Docket: NRC-2018-0066

NUREG-2224, Dry Storage and Transportation of High Burnup Spent Nuclear Fuel, Draft Report for Comment.

RE: NUREG-2224 High Burnup Storage and Transport Draft Comments from Donna Gilmore,
Docket NRC-2018-0066

Figure 20 Cladding Outer Surface Oxide Layer Thickness versus Rod Average Burnup (Gigawatt days/ton of uranium). NWTRB 2010

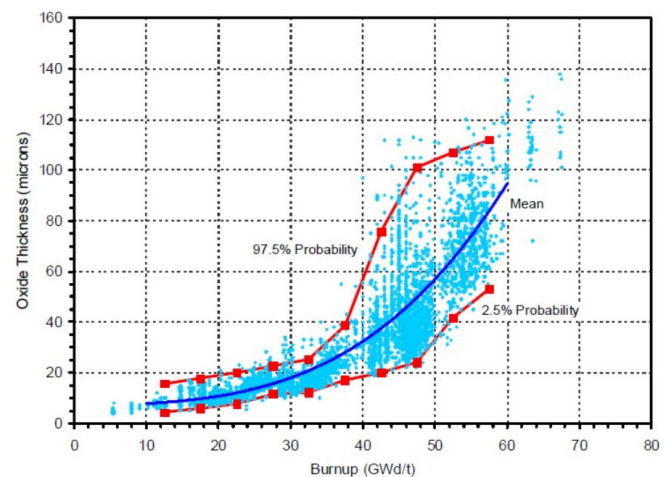
In the Nuclear Waste Technical Review Board (NWTRB) 2010 report regarding the *Technical Basis for Extended Storage of Used Fuel for Storage and Transport*,¹ it references over 4,400 measurements from commercial fuel-rods taken from reactors around the world (Figure 20). The data shows zirconium oxides and zirconium hydrides are created in moderate and high burnup fuel, with significant increases starting at ~35 GWd/MTU. There is a direct correlation with oxides and hydrides. See NWTRB report for the Chart showing the hydrides. Zirconium metal hydrides cause damage to the cladding, making it more brittle, thinner, and increases

hydrogen gas explosion risks if fuel rods are exposed to air (whether in pool or dry storage). Zirconium hydrides ignite at only 270 degrees Celsius.

The NRC continues to ignore this operating data. I have asked in numerous NRC technical meetings over the years why the NRC ignores this data, including at the one public meeting held on NUREG-2224 (September 6, 2018). Normally the NRC will respond with some type of answer to my questions. When I ask about this operating data, they don't even do that. They change the subject. I would like a response as to why the NRC ignores this data.
